Greater Lyttonsville Sector Plan, Work Session #1

Greater Lyttonsville Sector Plan: Work Session #1

Testimony/Correspondence/Petition Summary - Greater Lyttonsville Sector Plan

Figure 1

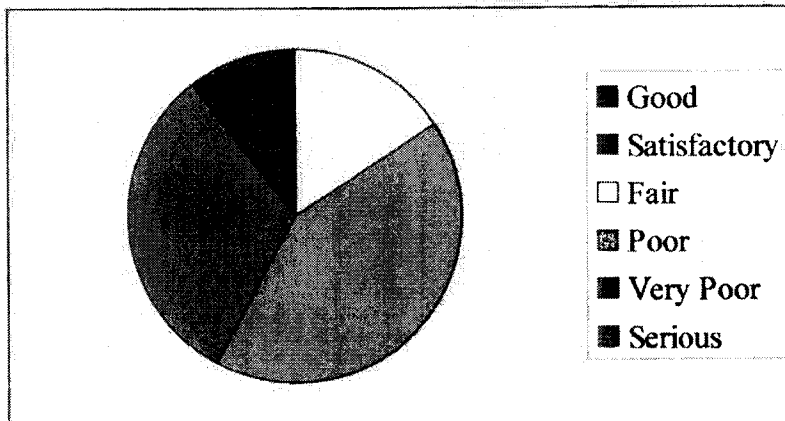
For Rosemary Hills, PCI measurements in the most recent two rounds (2013 and 2015) are shown for each road segment in Table 2. There are 19 individual street segments in this table. **You will readily observe that 85% of roadways in Rosemary Hills are either in a poor, very poor, or serious condition.**

Figure 2

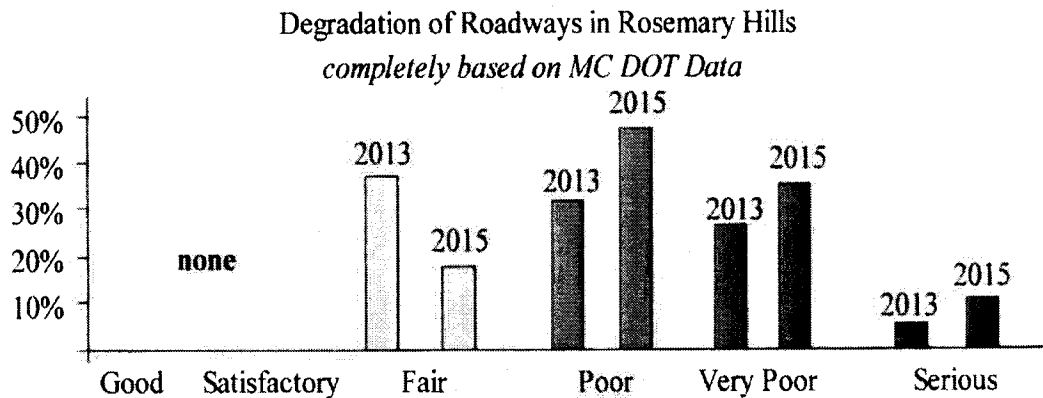
Every single one of the roadway segments shown in Table have deteriorated between 2013 and 2015. The average deterioration rate is 9 PCI points in two years. This has been sufficient to move many of our roadways from the Poor to Very Poor category. Unabated, this trend, shown in Figure 2, will continue.

16th Street (2nd Ave to East-West Hwy, Looking Northwest)
Proposed Section: Separated Bike Lanes (two-way)

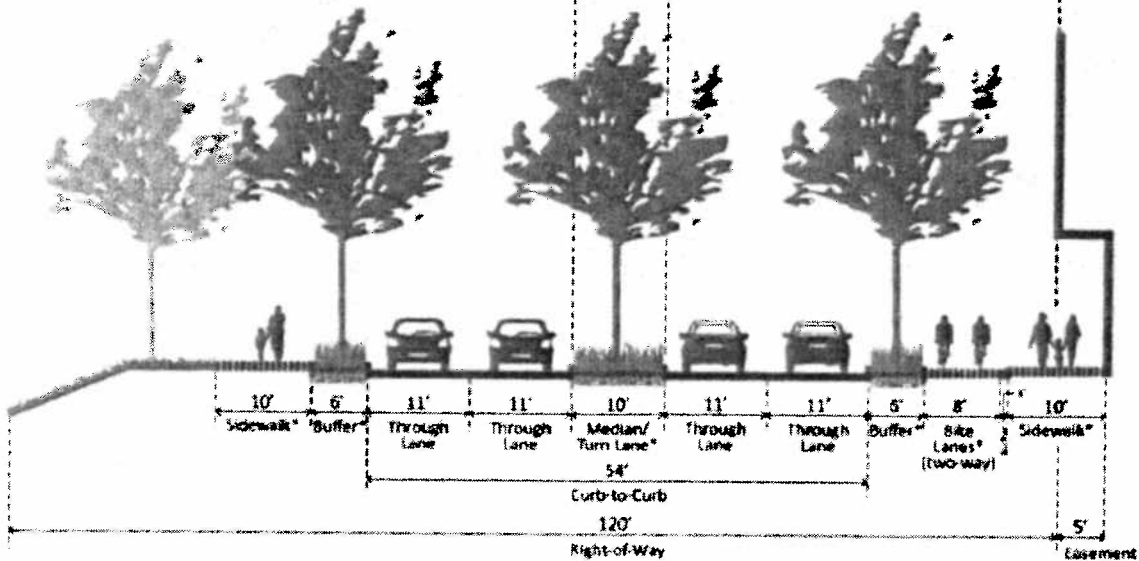
Many of those familiar with the road diet (Slide 2) have expressed concern of evening traffic congestion along northbound 16th Street and, consequently, on East-West Highway and Spring Street. The alternative road diet (Slide 3) utilizes the available State right-of-way width of approximately 102 feet at the Spring Center. It retains the three northbound lanes of 16th Street to preclude congestion during the evening peak period. However, the curbside northbound lane is available for metered parking at all other times; this parking will support the small retail businesses of the redeveloped Spring Center. The same lane includes a far-side bus stop at the entrance of the redevelopment.

The other elements of the Sector Plan's road diet remain: southbound sidewalk, landscaped median, a two-way cycle track and a wide sidewalk along the redeveloped Spring Center. Slides 5 through 10 are for reference.
